Product Change Notification (PCN)

PCN # 2B-2024

Laird Part Number	Old Rev	New Rev	Description
T700_SMARC_SOM_4r16e	10	20	Tungsten 700 SMARC SOM: Genio 700 / 4GB / 16GB eMMC
T700_SMARC_SOM_8r16e	10	20	Tungsten 700 SMARC SOM: Genio 700 / 8GB / 16GB eMMC

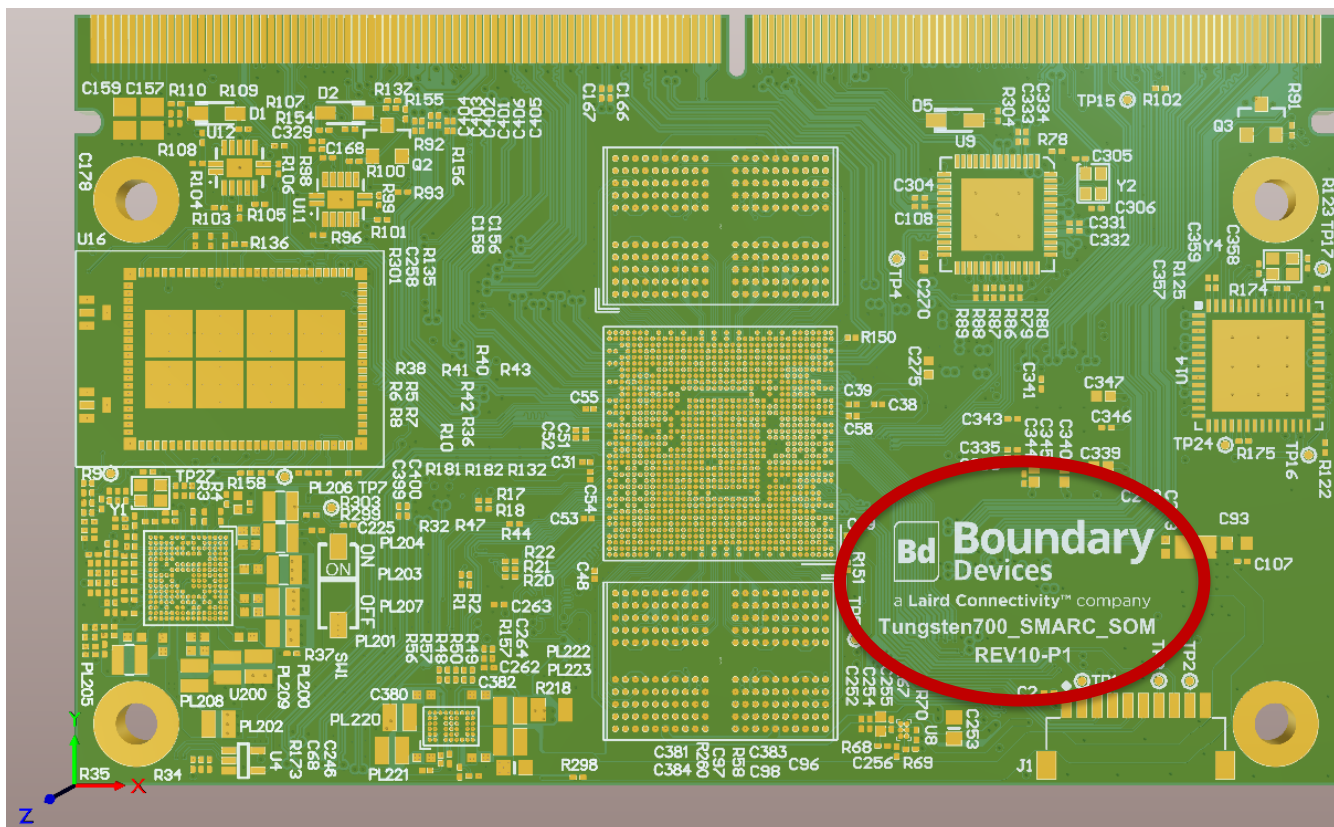
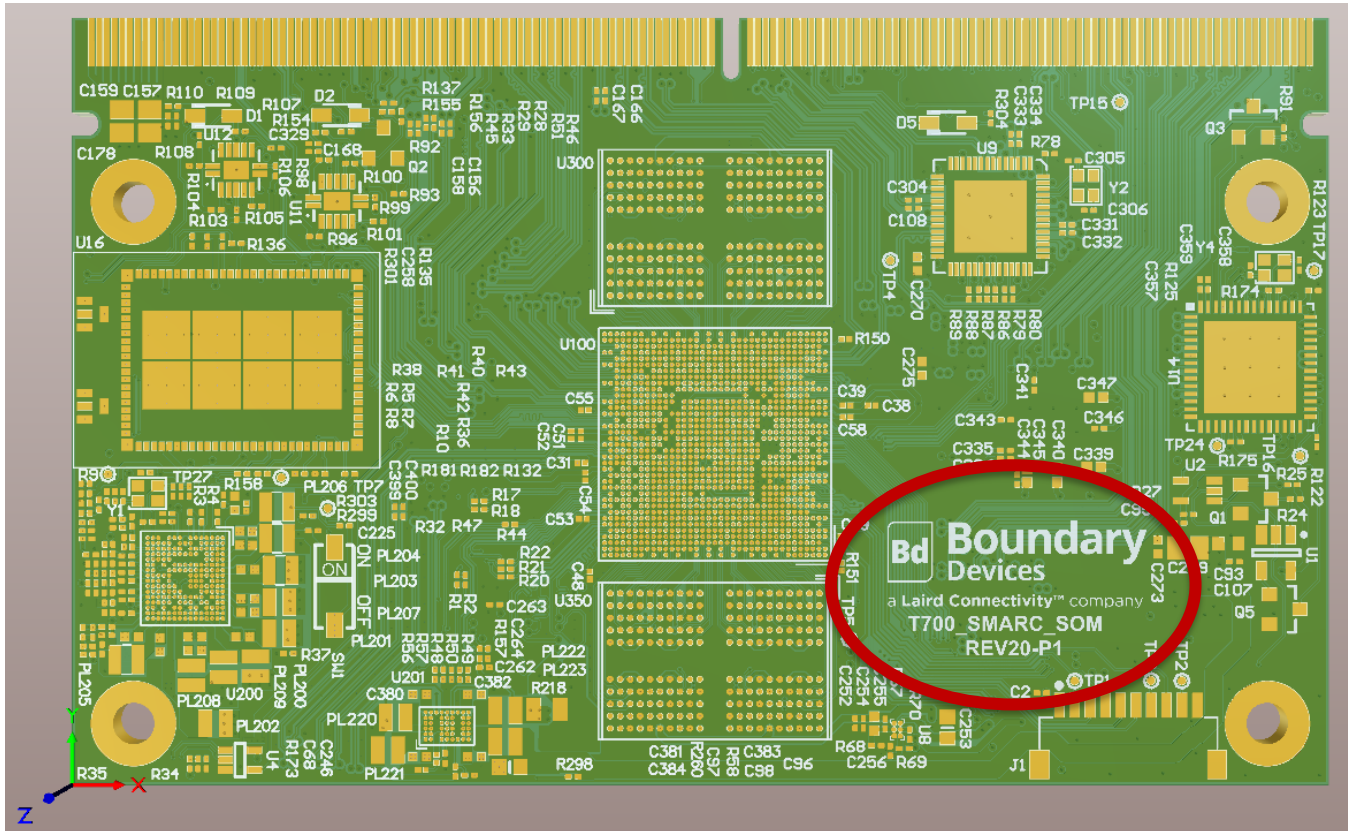
Prior to this PCN, the silk screen on the SOM showed as Tungsten700_SMARC_SOM REV10-P1.

Here's an example of the silk screen for REV10-P1 SMARC SOM

After this PCN, the silk screen was updated to T700_SMARC_SOM REV20-P1

Here's an example of the newest T700_SMARC_SOM REV, REV20-P1
